**Assessment of Sixteen (16) Protected-Size Trees
at and adjacent to
62 Ellenwood Avenue
Los Gatos, California**

Prepared for:
Sean Mullin, Associate Planner
Town of Los Gatos Community Development Department
110 E. Main Street
Los Gatos, CA 95030

Report by CTA
6/3/2020

The CTA assessed the entire set of plans dated 4/23/20 (by Arcanum Architecture, BKF Civil, and Studio Green).

Walter Levison, Contract Town Arborist 6/3/2020
Markup of Sheet L0.0 Dated 4/23/2020 Showing
Sixteen (16) Protected-Status Trees
(Both on and Adjacent to the 62 Ellenwood Property)

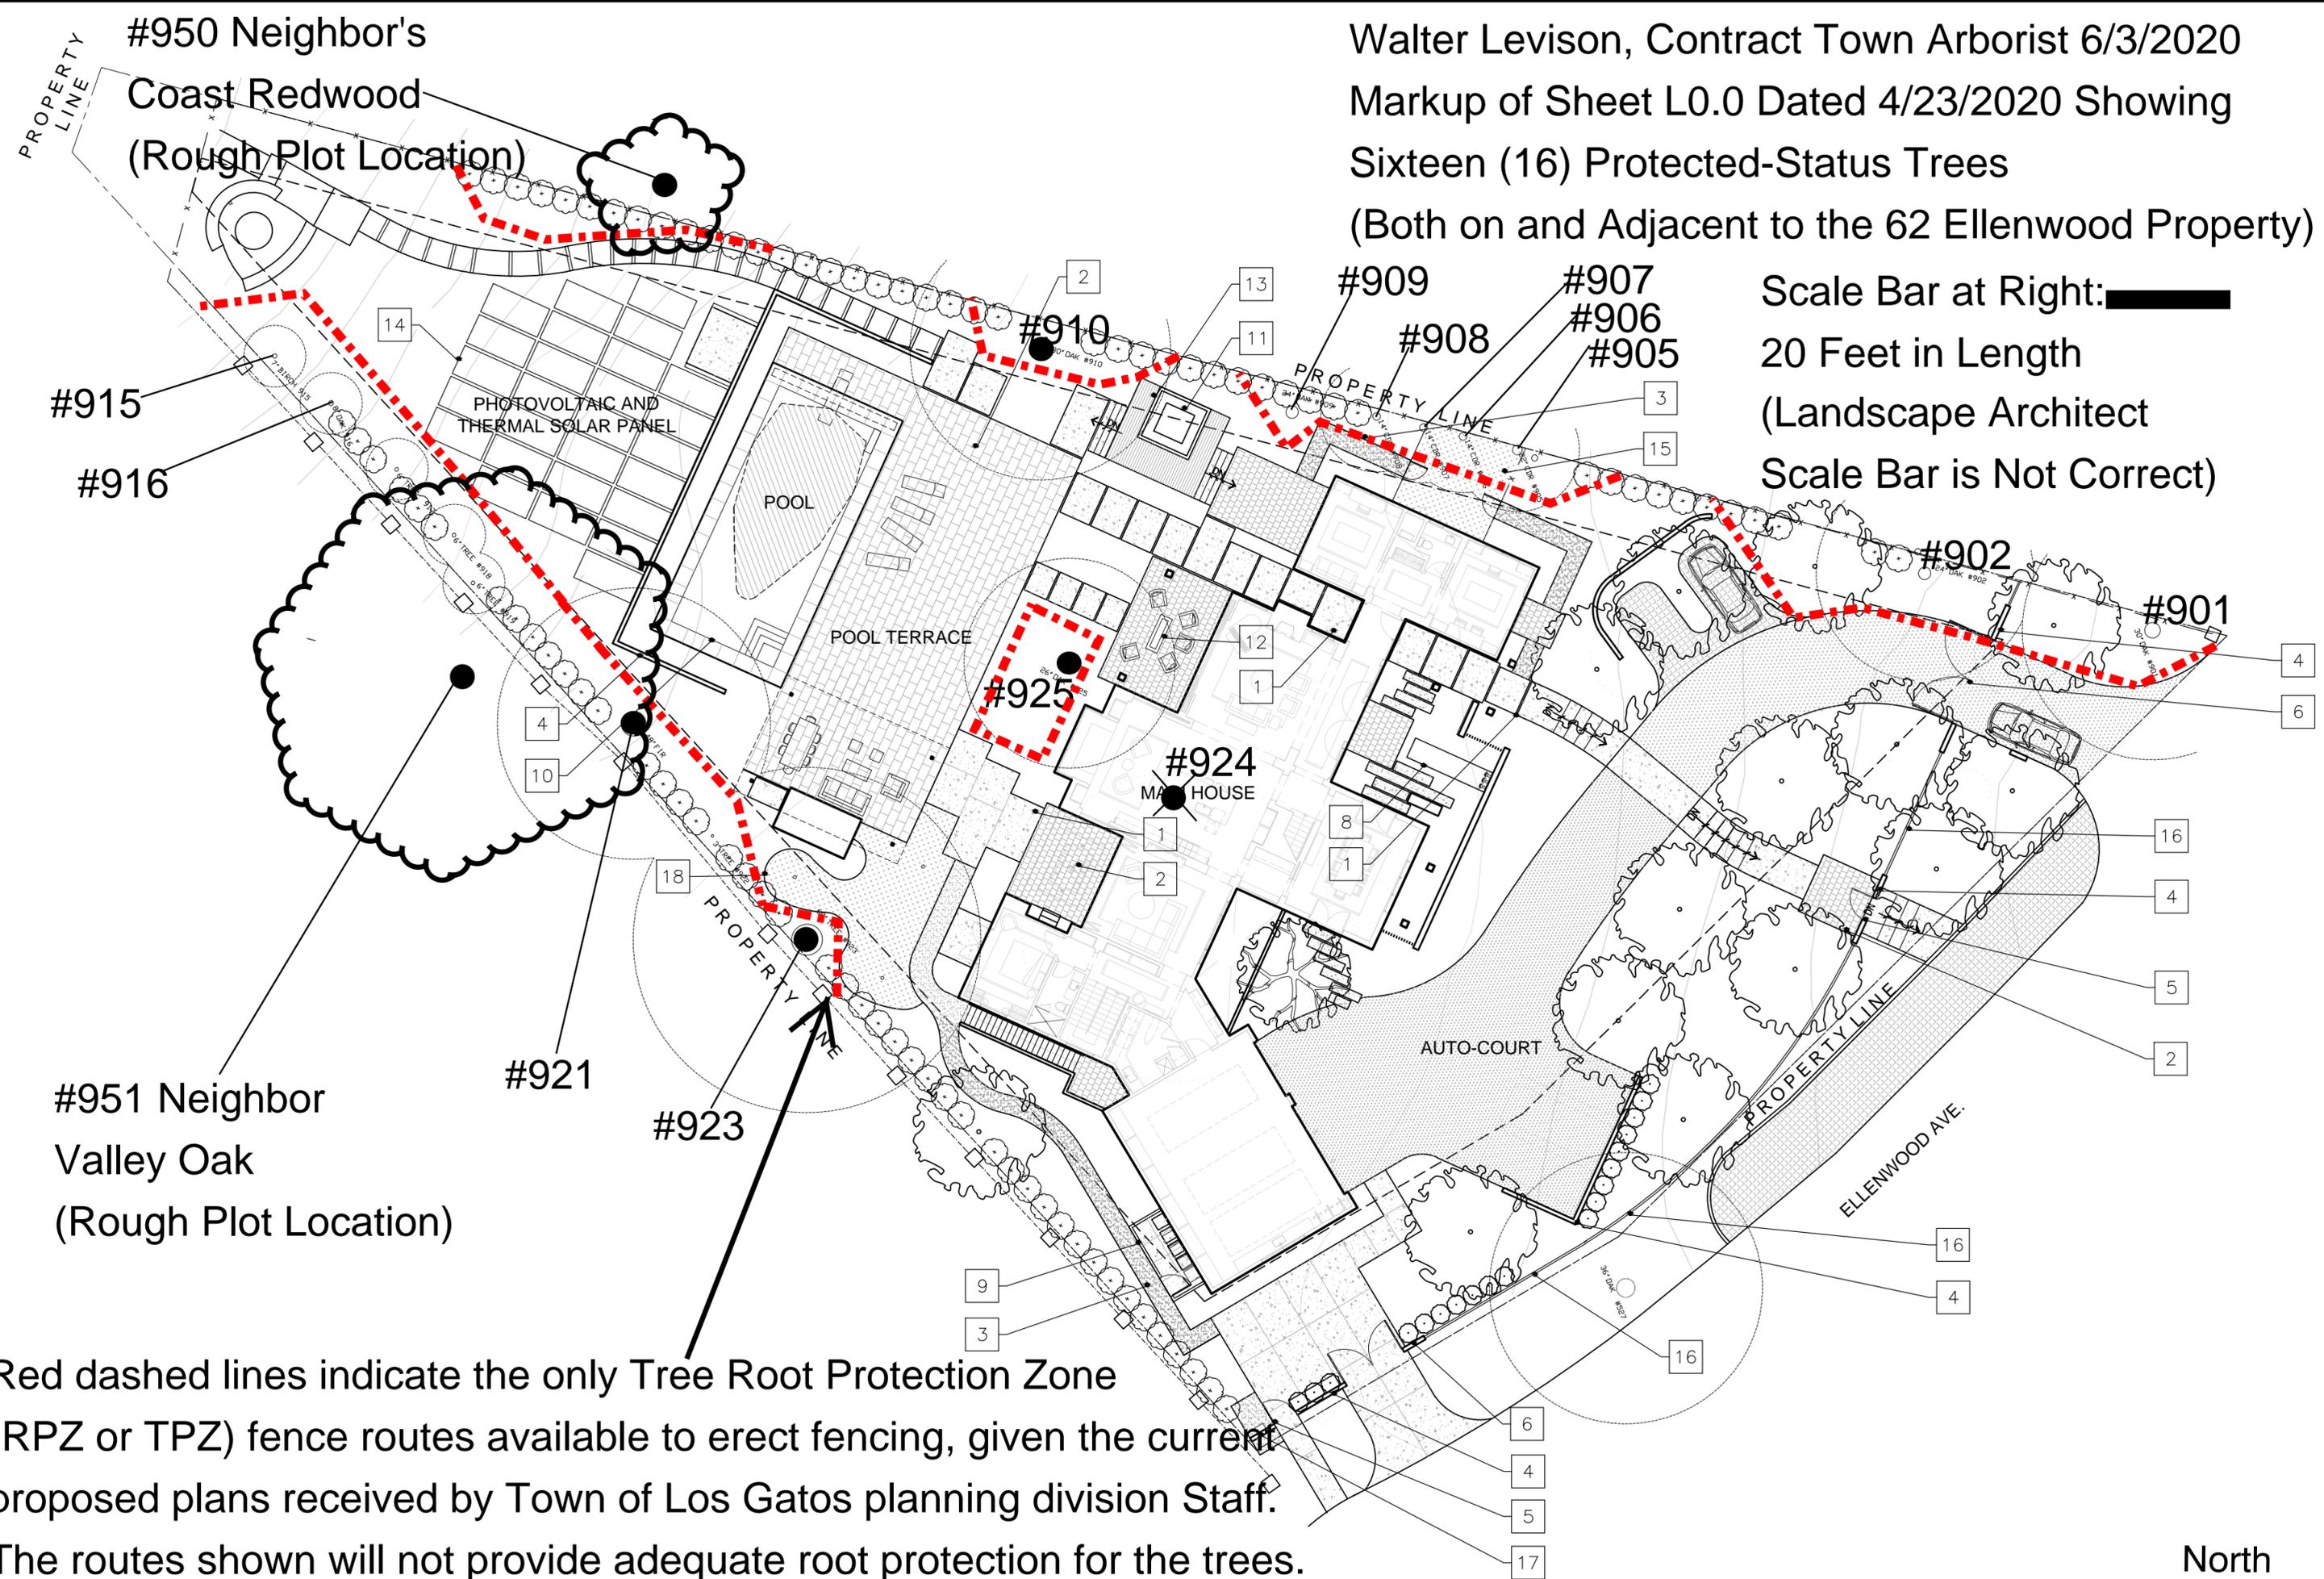
- c. Canopy driplines for the two neighbor trees were drawn out by the CTA to approximate scale, using black clouding.
- d. Red dashed lines indicate chain link fencing tree root protection zones or root protection zones (TPZ or RPZ). However, as noted by the CTA on the tree map markup, the current available locations for TPZ fencing are not adequate to allow for root preservation or protection, given the current proposed extent of site work indicated on the applicant’s set of plans dated 4/23/2020. Most of the “Critical Root Zone” minimum required construction offset distances for protection of trees’ structural root plates will be violated, if the proposed plans are built out as currently proposed by the applicant.

Red dashed lines indicate the only Tree Root Protection Zone (RPZ or TPZ) fence routes available to erect fencing, given the current proposed plans received by Town of Los Gatos planning division Staff. The routes shown will not provide adequate root protection for the trees. See the arborist report for analysis of construction-related impacts to trees expected to occur as a result of applicant-proposed site work.
